**ZONING AMENDMENT,
PLANNED UNIT DEVELOPMENT &
SUBDIVISION STAFF REPORT****Date: July 9, 2015****NAME**

La Belle Subdivision, Resubdivision & Addition to Lot 1

LOCATION5951 & 5955 Old Shell Road and 14 East Drive
(Southwest corner of Old Shell Road and East Drive)**CITY COUNCIL
DISTRICT**

Subdivision approval to create 1 legal lot of record, Planned Unit Development Approval to allow multiple buildings on a single building site and shared access between two building sites, and Rezoning from R-1, Single-Family Residential District, and B-2, Neighborhood Business District, to B-2, Neighborhood Business District to eliminate split zoning in a proposed Subdivision and allow construction of a parking lot.

SITE PLAN

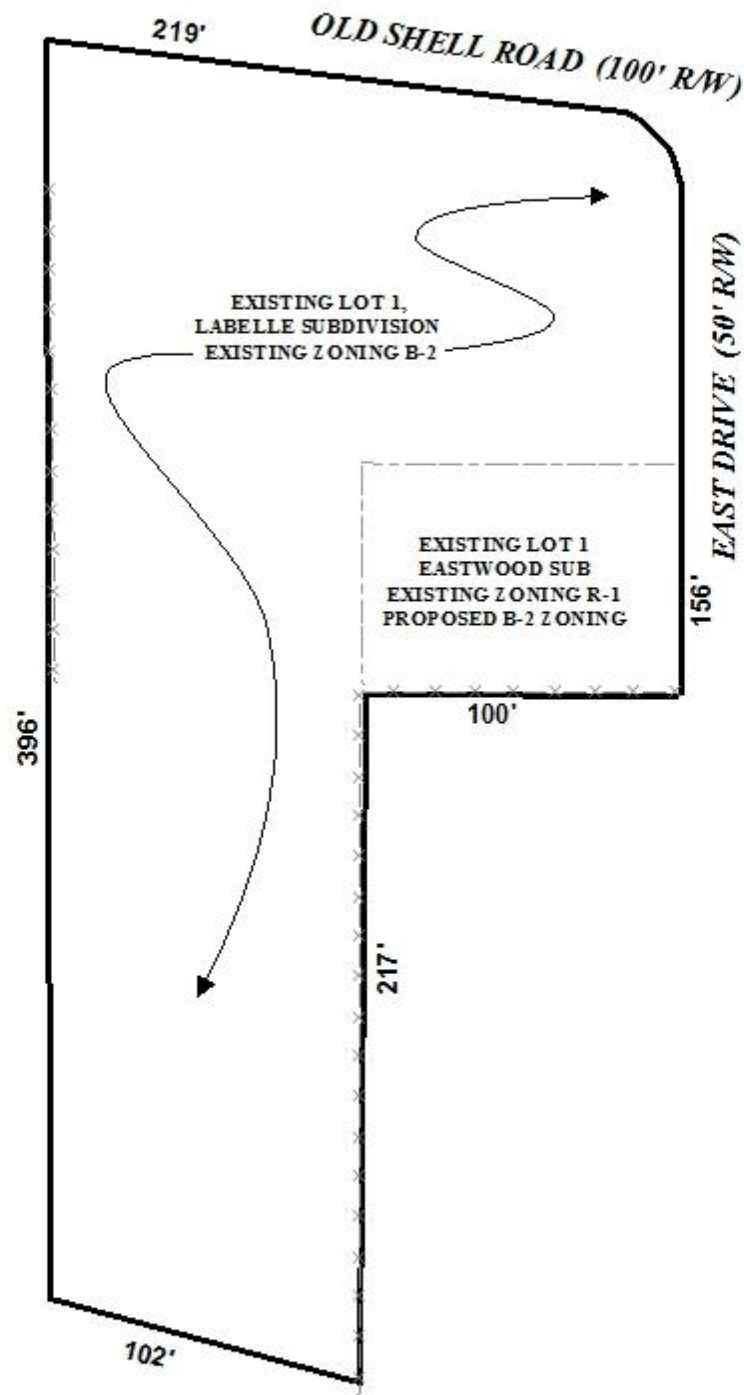
The applicant proposes to develop the residentially-zoned portion of the site to include paved parking, trees, landscaping and an additional entrance for the development from East Drive. Currently, the site does not have access to East Drive, thus all traffic associated with the restaurants enters and exits the site via curb-cuts onto Old Shell Road. Access to East Drive will afford access to and from Old Shell Road via an intersection with a traffic signal. As designed, however, the curb-cut to East Drive will be angled, creating an awkward turning angle for vehicles entering the site from southbound East Drive. It should be noted that a large oak tree in the proximity of the proposed curb-cut is the reason for the proposed design.

While the applicant is requesting almost identical approvals as were granted to the site previously, it should be noted that it has been 7 years since the initial ticket, and recent changes in the area make approval of the current request less desirable. In 2014, an application for a project on the same street brought forth concern from several citizens in the neighborhood about the amount of increased traffic on East Drive. The current proposal would have longer hours of operation, and greater intensity than the other project which resulted in neighborhood concerns. In addition the current proposal would result in further increased traffic, including delivery trucks, garbage trucks and restaurant patrons, on East Drive with customers using the newly proposed curb-cut on East Drive, as well as increasing light penetration of vehicle headlights, required lighting of the parking lot, and the proximity of vehicle to adjacent residences. Also, the current proposal is much closer to the East Drive and Old Shell Road intersection than the other project which raised so much concern in the neighborhood, therefore the likelihood of increasing traffic congestion at the intersection could be much more problematic. As a response to these concerns, the applicant revised the site plan in 2014 removing the proposed access to East Drive, and such access should be denied with this application as well.

Access to the new parking area from the existing parking area will be via a 24-foot wide driveway that will extend between two existing parking spaces. As no curbing or radius is provided for the driveway, cars parked in the existing parking spaces will likely be at high risk for damage by other vehicles, including delivery trucks, which will inevitably choose to enter or exit via the East Drive curb-cut. Staff recommends that the two abutting parking spaces be eliminated and replaced with curbed planting islands.

A sidewalk along East Drive is not depicted where the new parking area is proposed. As the site is commercial, a sidewalk waiver request must be submitted to the Planning Commission for consideration, or a sidewalk must be provided.

Finally, parking areas with more than 10 spaces and that are used at night must be illuminated. Any existing and any new lighting must comply with the Zoning Ordinance requirements, including the provision that “lighting facilities used to illuminate signs, parking areas, or for other purposes shall be so arranged that the source of light does not shine directly into adjacent residence properties or into traffic.” The applicant must submit information regarding new parking area lighting fixtures (including photometrics), indicate the locations on the site plan, and submit information regarding how any existing site lighting will be modified to comply with the requirements of Sections 64-4.A.2. and 64-6.A.3.c. of the Zoning Ordinance. The site plan illustrates proposed 36-inch high shrubs along the existing 6-foot high privacy fence along the rear of the residential properties on East Drive to better shield car headlights.

The existing dumpsters do not meet the 10-foot setback requirement for commercial sites abutting residentially zoned properties. While an appropriate dumpster enclosure is proposed, there appears to be sufficient room to relocate the dumpsters and the proposed enclosure to meet all setback requirements. In 2014, the applicant submitted a site plan illustrating the non-compliant dumpsters relocated 15’ away from the adjacent residentially zoned properties. It should be noted that relocation of dumpsters will require sanitary sewer connections.

The current restaurants share the existing parking, and the site currently requires 62 parking spaces (staff measurements, including outdoor seating areas), however, only 60 are provided as two were removed when a concrete driveway apron was constructed without permits to the R-1 property. The proposed additional parking will only add 11 parking spaces to the overall site. Elimination of the unpermitted access would allow the restaurants to comply with the minimum parking requirements, and allow the R-1 site to be utilized for a residence (a permit for a single-family residence was issued by the Urban Development Department in 2004, however, the house was never constructed).

It should also be pointed out that when the original site was rezoned in 2001, one of the conditions was “denial of access to East Drive and the elimination of the existing curb cut to East drive with the installation of city standard curb and gutter and appropriate fill.” The request at hand will circumvent the denial of access to East Drive if approved by the Planning Commission. However, the existing Zoning conditions also include the requirement of a 15-foot wide vegetative buffer and 6 foot high wooden privacy fence between where the site abuts residentially zoned property, and the proposed new parking area is illustrated as providing this same protection.

Finally, there was an unpermitted addition to the Picklefish building after the initial PUD approval in 2011, which is not reflected on the submitted site plan. A condition of approval in 2014 was the obtaining of a demolition permit for this unpermitted structure, which has not been obtained.

- 1) revision of the site plan to remove access to East Drive;
- 2) all site lighting to comply with Sections 64-4.A.2. and 64-6.A.3.c. of the Zoning Ordinance, and the applicant must submit documentation regarding lighting compliance, including the physical location of new lighting on the property and a photometric plan of the lighting;

- 4) obtaining a demolition permit for the unpermitted structure at the rear of the Picklefish building;
- 5) revision of the site plan to illustrate a sidewalk along and East Drive, or a successful sidewalk waiver application;

- 6) compliance with Engineering comments (*ADD THE FOLLOWING NOTES TO THE PUD SITE PLAN: 1. Any work performed in the existing ROW (right-of-way) such as driveways, sidewalks, utility connections, grading, drainage, irrigation, or landscaping will require a ROW permit from the City of Mobile Engineering Department (208-6070) and must comply with the City of Mobile Right-of-Way Construction and Administration Ordinance (Mobile City Code, Chapter 57, Article VIII). 2. A Land Disturbance Permit application shall be submitted for any proposed land disturbing activity with the property. A complete set of construction plans including, but not limited to, drainage, utilities, grading, storm water detention systems, paving, and all above ground structures, will need to be included with the Land Disturbance permit. This Permit must be submitted, approved, and issued prior to beginning any of the construction work. 3. Any and all proposed land disturbing activity within the property will need to be submitted for review and be in conformance with Mobile City Code, Chapter 17, Storm Water Management and Flood Control); the City of Mobile, Alabama Flood Plain Management Plan (1984); and, the Rules For Erosion and Sedimentation Control and Storm Water Runoff Control. 4. The approval of all applicable federal, state, and local agencies (including all storm water runoff, wetland and floodplain requirements) will be required prior to the issuance of a Land Disturbance permit. The Owner/Developer is responsible for acquiring all of the necessary permits and approvals. 5. The proposed development must comply with all Engineering Department design requirements and Policy Letters.);*

- 7) provision of a revised PUD site plan prior to the signing of the Final Plat; and
- 8) full compliance with all other municipal codes and ordinances.
